August 31, 2021
GZA File No. 175211.00

RE: Engineering Peer Review
Proposed Residential Development
300 Stone Street (Lot 2)
Walpole, MA

In accordance with our proposal, dated May 21, 2021, GZA GeoEnvironmental, Inc. (GZA) is pleased to provide the Town of Walpole Zoning Board of Appeals (Client) this engineering peer review letter for the proposed single-family dwelling and associated surface grading at 300 Stone Street, Walpole (Site). The Project Applicant is Walsh Brothers Building Company (Applicant).

Figure 2: FEMA Flood Insurance Rate Map (2012)

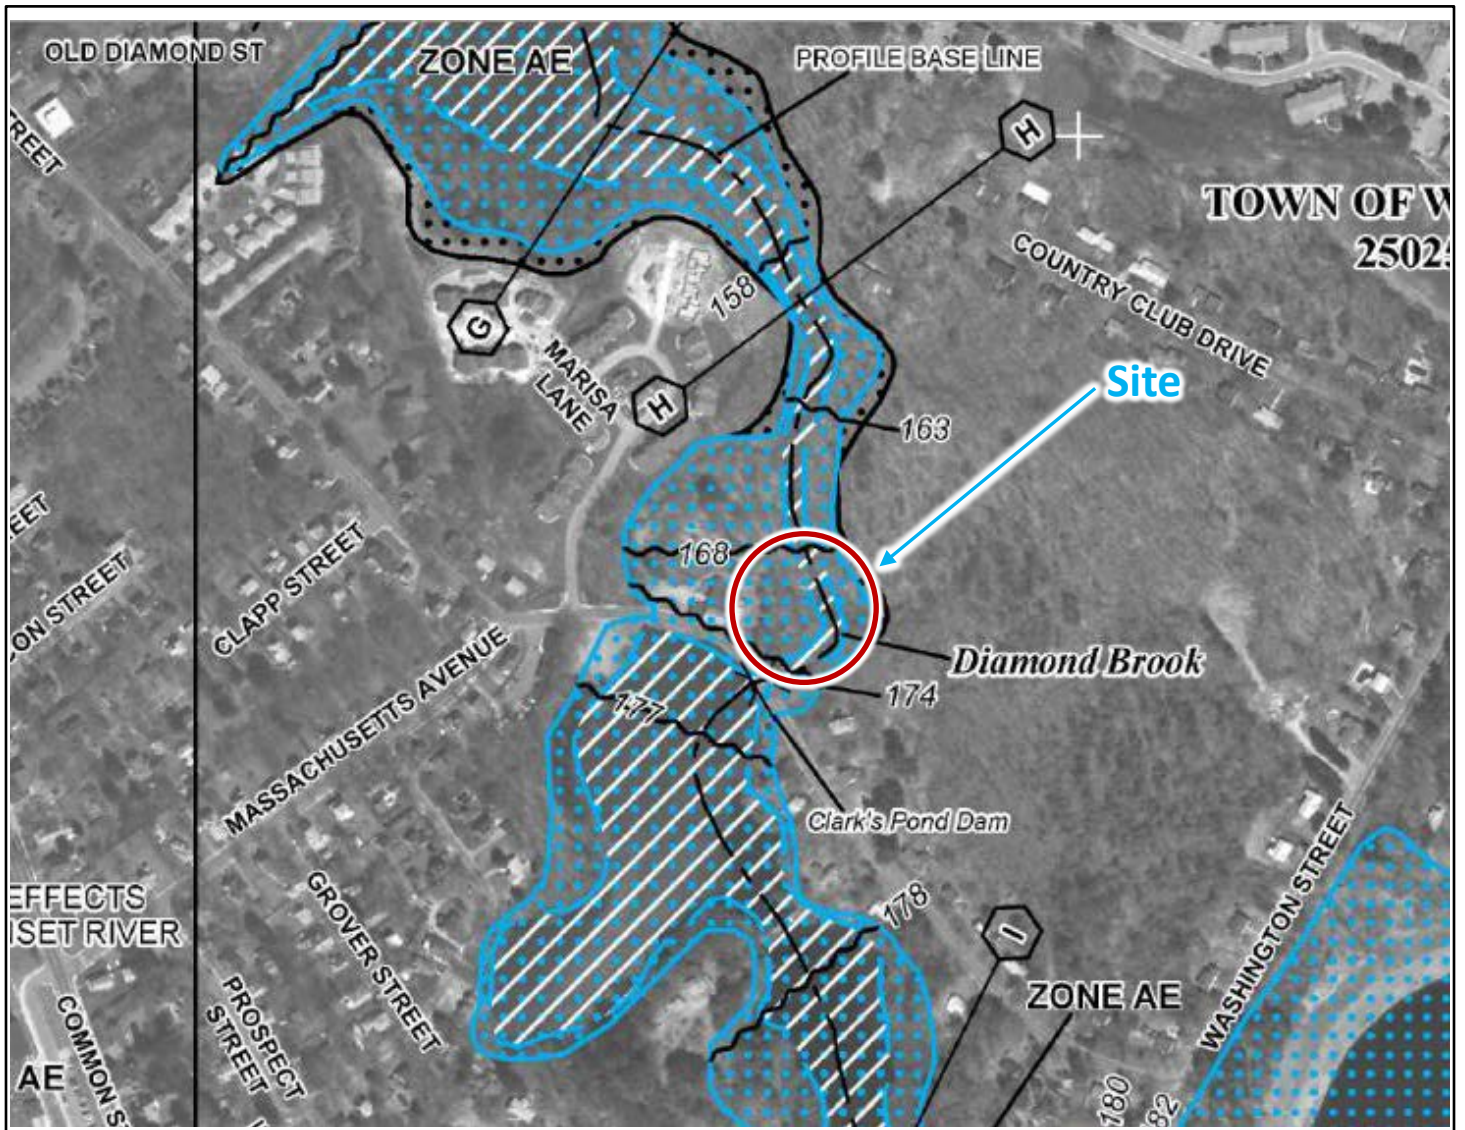
The Site is situated within Walpole's Flood Plain Protection Overlay District and is fully encompassed within the 100-year floodplain as published in the latest Flood Insurance Rate Map (FIRM) by FEMA (effective date July 17, 2012). Relevant portions of the FIRM are presented in **Figure 2**. Base flood water surface elevation across the site ranges from approximately 170.0 to 174.0 (NAVD88), based on the published FIRM. The 100-year flood level in Clarks Pond, in the vicinity of the Stone Street dam outlet is at Elevation 177.0. Based on the average roadway grade elevation of 176.5 (taken from the GLM site base map), the dam/roadway would be likely overtopped and susceptible to an erosion failure during the 100-year flood. Shallow flooding depths of about 0.5 foot would be expected across the majority of the Site, under the 100-year event (not including dam failure). However, flood depths in the brook would be more in the range of 2 to 3 feet, with related higher flow velocities.

additional regulatory requirements including more frequent visual dam inspections, potentially larger spillway design floods, and preparation of an Emergency Action Plan. Additionally, based on the information in the effective FIRM, the dam is likely to overtop during the 100-year flood which could result in dam failure (and by default result in damage or destruction of Stone Street, which forms the dam's embankment). Encroachment of the Spring Brook floodplain due to filling may alter flow velocities, which could raise water levels up to or beyond the Stone Street dam outlet elevation. This could result in exacerbating the overtopping potential of the dam.

Figure 3: Proposed Development at 300 Stone St Lot 2, Walpole, MA

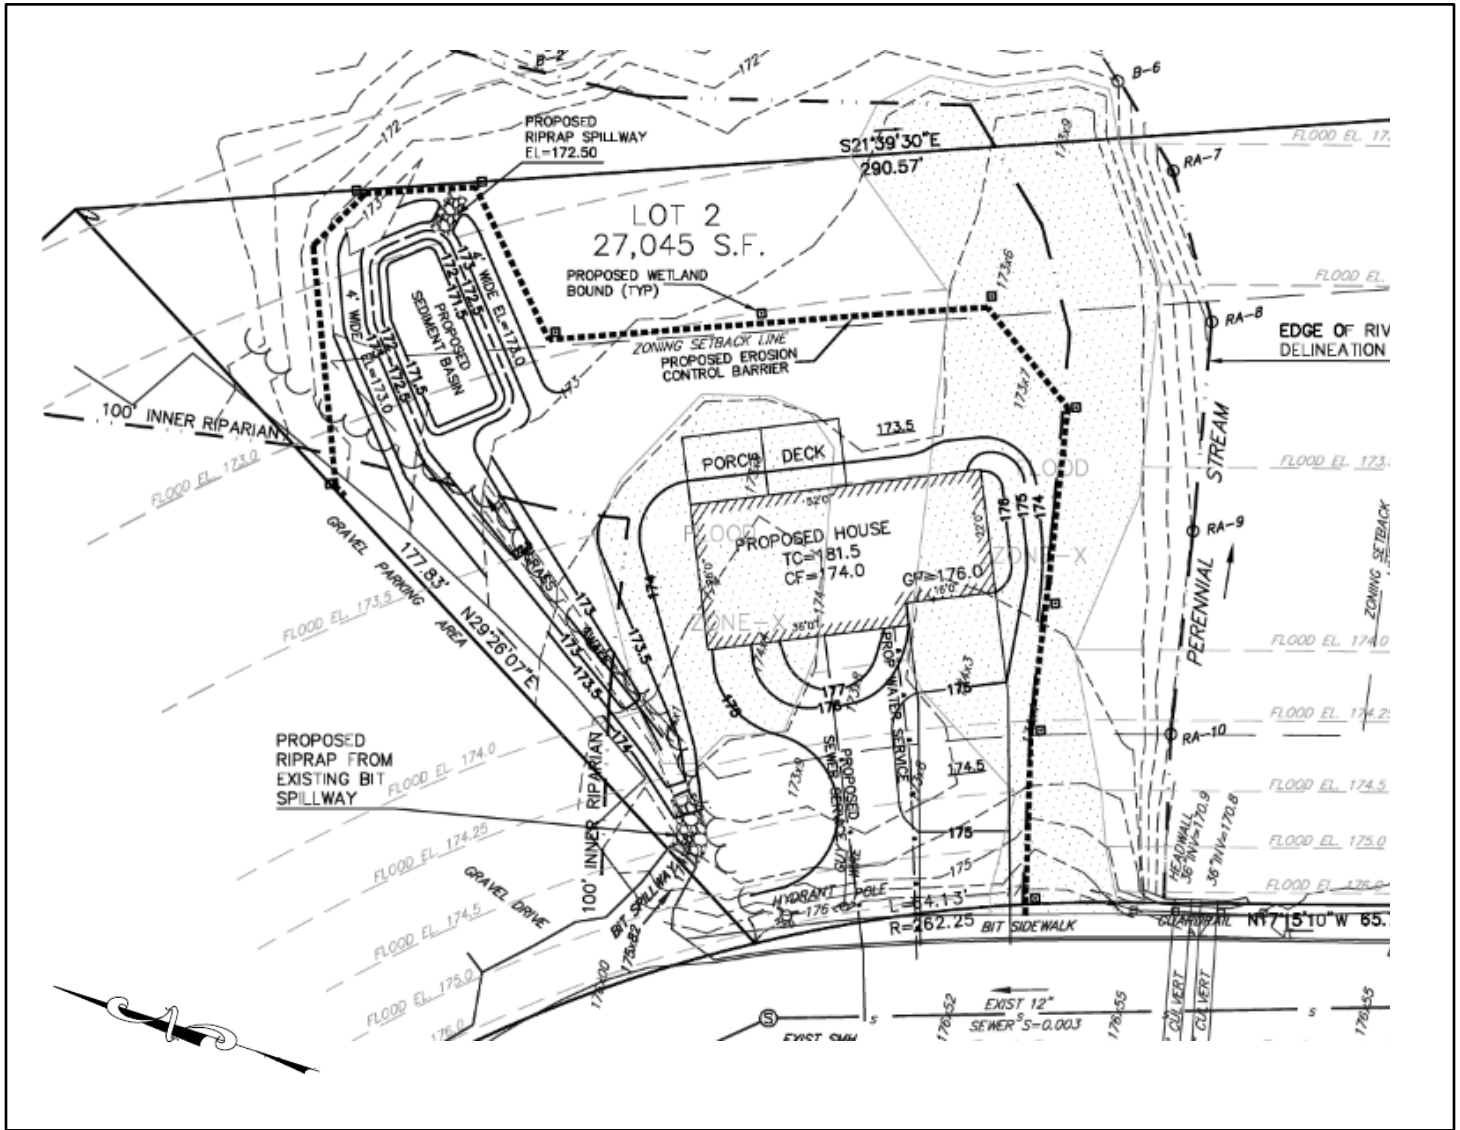
GZA's understanding of the applicant's proposed dwelling configuration and floodplain mitigation measures were primarily derived from review of the GLM engineering drawings (see **Figure 3**). The dwelling is to have a 1,460 ft² footprint with slab-on-grade foundation. The top of foundation slab is to be set at elevation 174.0 with a finished ground floor elevation of 176.0, which is above the published FEMA 100-year flood elevation. However, other portions of the property surrounding the dwelling structure will remain in the 100-year floodplain. Based on the Applicant's documentation, mitigation measures due to the proposed land disturbance will primarily include creation of new flood storage to compensate flood volume loss due to filling and re-grading of the Site. Based on the use of simple flood storage

In addition, the proposed development is to include a small “sediment basin” located near the northwest corner of the property (**Figure 3**). This basin is to be about 1.5 feet high, with a riprap spillway set at a level about 0.5 feet below the top of the basin. A new grass-lined swale will allow roadway stormwater from the existing paved swale, along with some site runoff, to enter the basin. It appears that the basin will operate as a detention basin, however it is unclear how this structure’s storage volume and spillway configuration were sized (i.e. design storm) and how the basin would operate under the 100-year storm. Please note that GZA did not review regulatory requirements for the proposed detention basin per Massachusetts Clean Water Act.

4. Additional hydrologic and hydraulic engineering information should be provided related to the design of the Sediment Basin. Specifically, an inflow/outflow storage routing computation should be provided that quantifies the contributory rate of runoff to the basin emanating from the roadway and from the Site. How accumulated sediment will be removed and other maintenance/performance of the basin under the 100-year flood should be included.
